DELEGATED APPLICATION REPORT

SITE ADDRESS: Warren Creek, The Warren, Caversham, Reading, RG4 7TQ

APPLICATION NUMBER: 231270/FUL (new reference: PL/23/1270)

PROPOSAL: Demolition of existing dwelling and outbuildings and the erection of a 4-bed detached dwelling with garage.

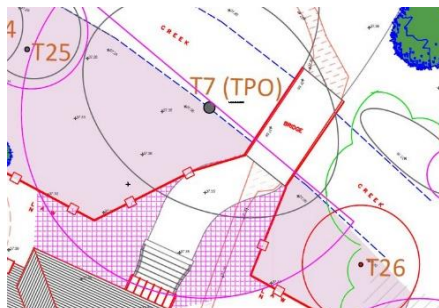
- A small area within the RPA of T5 appears as soft landscape that is not protected by the provisions of the TPP (the plain, white area) – however, looking at site photos, it appears this corner of the driveway is indeed surfaced with existing hardstanding.

- While the no-dig surfacing within the RPA of retained trees is provisioned by the AMS and is included in the legend of the TPP, the plan itself does not indicate what is the extent/location of this provision – it appears, instead, these areas are left blank (white).
- In continuation to the bullet point above, it may be easier to show the existing hard standing (retained during construction) as ground protection and the provisioned temporary ground protection on a phase 1 plan, with the new No-dig surfacing within RPA of retained trees on a phase 2 plan. This is best evidenced by the excerpt below where the Temporary Ground Protection appears interrupted by the supposedly no-dig surfacing leading from the creek to the house. However, Temporary Ground Protection should be continuous within the RPA of T7 here, with the No-dig surfacing only laid after construction works are completed.

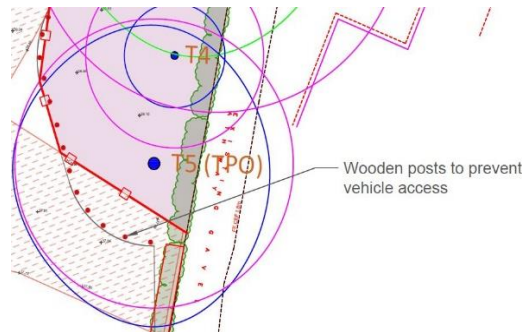
- The AMS and TPP by Duckworth Arboriculture indicate the group of trees near the site entrance will be removed on arboricultural grounds. The Landscape plan shows these are retained. I assume these were meant to be shown as new trees. Amendment is necessary
- 3x Quercus ilex sizes are given as 100mm diameter – I assume this is meant as 100mm girth
- The TPP indicates installation of a row of wooden posts that follow the edge of the proposed gravel driveway to prevent vehicles access off the provisioned driveway onto the soft landscaped area within the RPA of existing T5. These wooden posts (with a note on their specifications) should be included in the landscape plan.
